Date: July 12, 2024
To: All Vendors
Subject: Addendum #2

**REFERENCE: B058-24 CONSTRUCTION OF AIRPORT SUBSTATION AND
CONTROL BUILDING**

This Addendum forms part of the contract and clarifies, corrects or modifies original bid document.

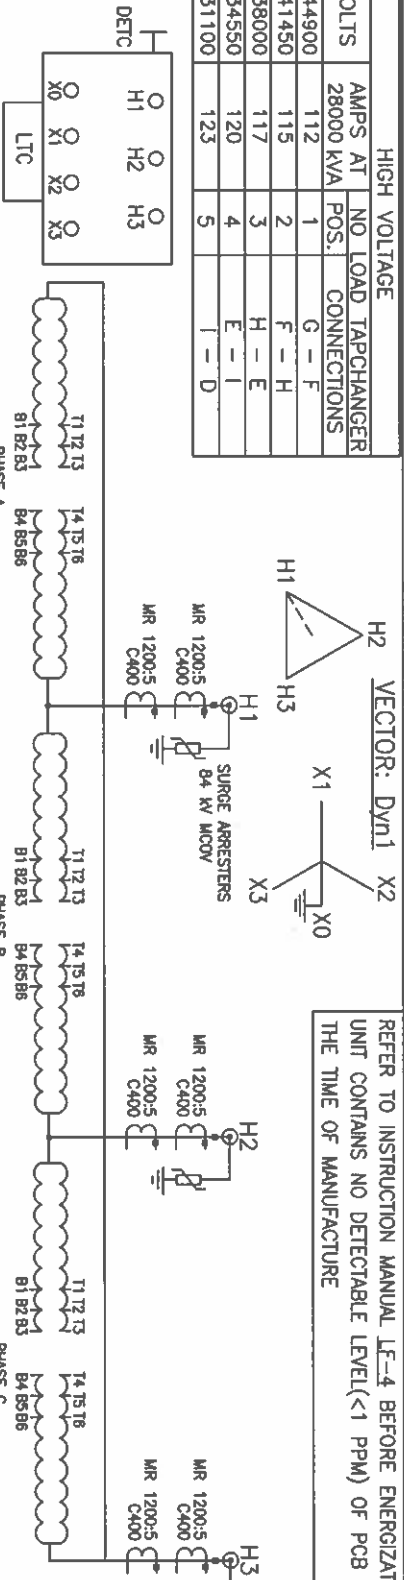
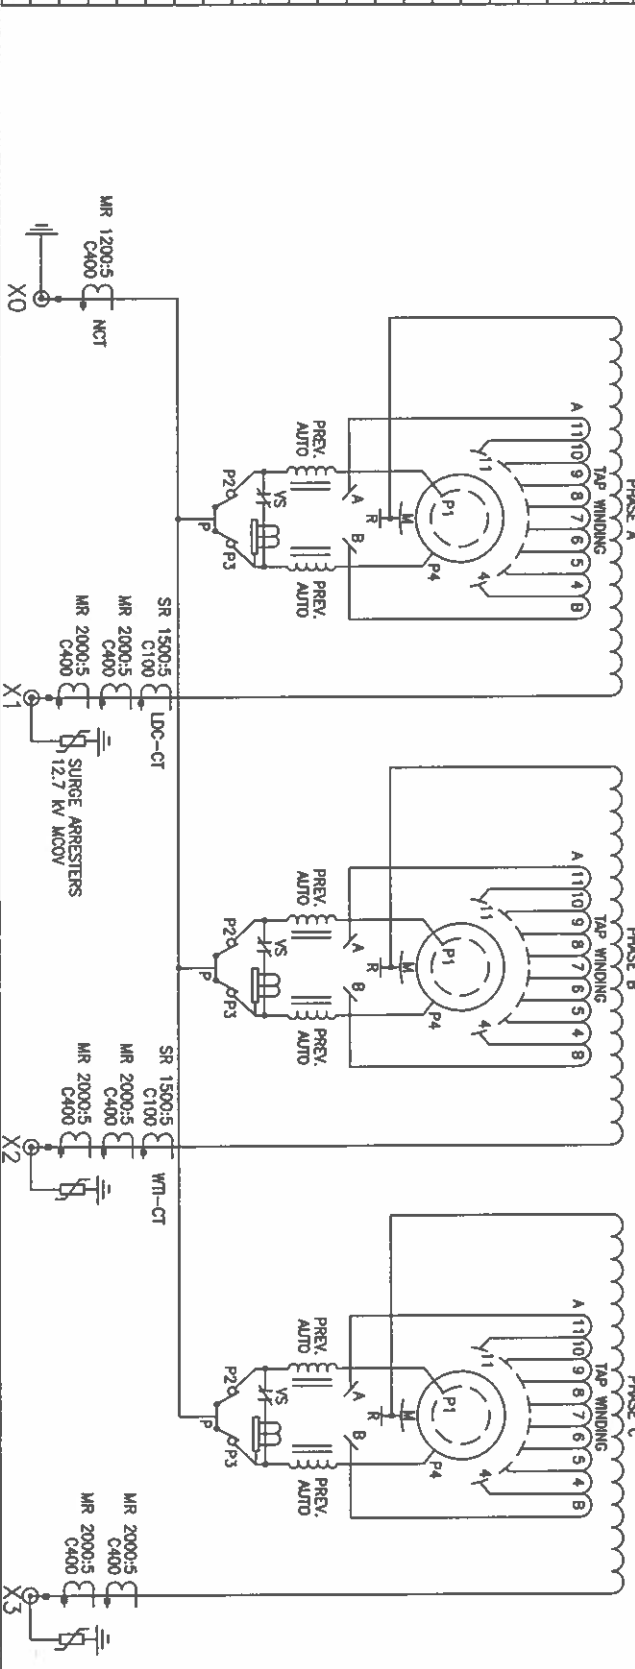
Question 10: Do you have the weight and dimensions of the equipment?

Answer 10: Yes, attached is a picture of the nameplate and manufacturer design as references.
